CRUISER
AIRCRAFT

SERVICE BULLETIN

No.: SB-SC-085

MODEL AFFECTED:	SportCruiser / PiperSport operating outside EASA rules
SUBJECT:	Substitution of Trail Tech light
AIRCRAFT AFFECTED:	All SportCruiser / PiperSport aircraft
COMPLIANCE:	According to the owner's decision.

Fig. 2: Oval hole

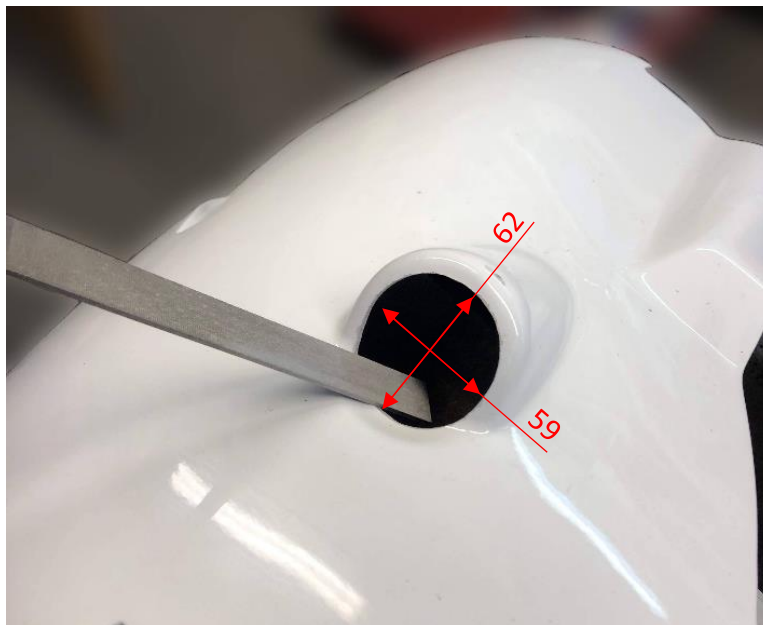
- Using a mock-up, drill a 2.5 mm hole. Then drill the hole to a diameter of 5.2 mm.
- Depending on the resulting joint thickness, choose a suitable screw (004 or 005) and a combination of washers (007 and 008).
- Test light (001) and verify the parallelism of the front of the light and the flange in the cowling after tightening the bolt. Due to the tightening of the screw, the parallelism may be broken. In this case, choose another pad.
- If necessary, repeat steps 5 to 7.
- Enlarge the front hole for the light to an oval with dimensions 62x59mm (see Fig. 2).

NOTE: Slight overlap between top of light lens and cowling is acceptable (approx. 5 mm).

Fig. 3: Electric scheme

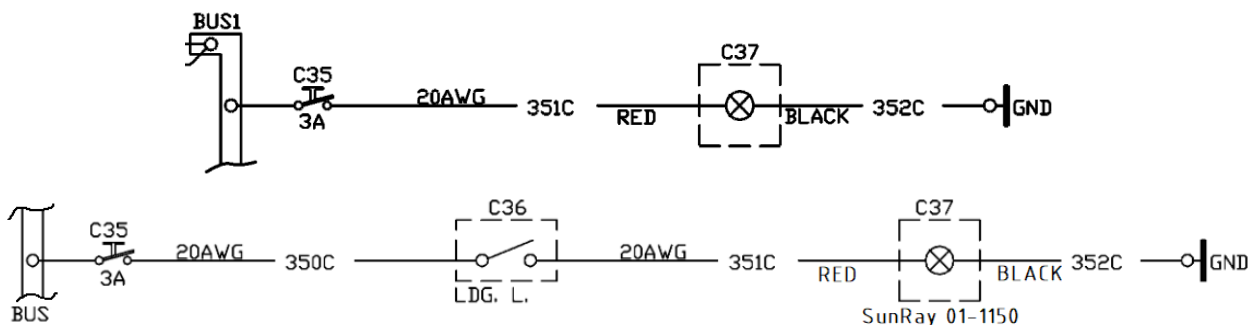
- Degrease the surfaces where the adhesive will be applied.
- Glue the pad with glue (012 or 013). Before the glue hardens, the position can be checked and adjusted using a mock-up. To fix the glued joint, use a screw and a nut (006). Protect the screw against sealing with plastic foil and vaseline.
- Clean the drilled hole from glue residues.
- The light has 5 wires, only two will be used. Red 351C (positive) and black 352C (ground), blind the other wires with a shrink tube (010). See Fig. 3. Valid scheme depends on airplane equipment.
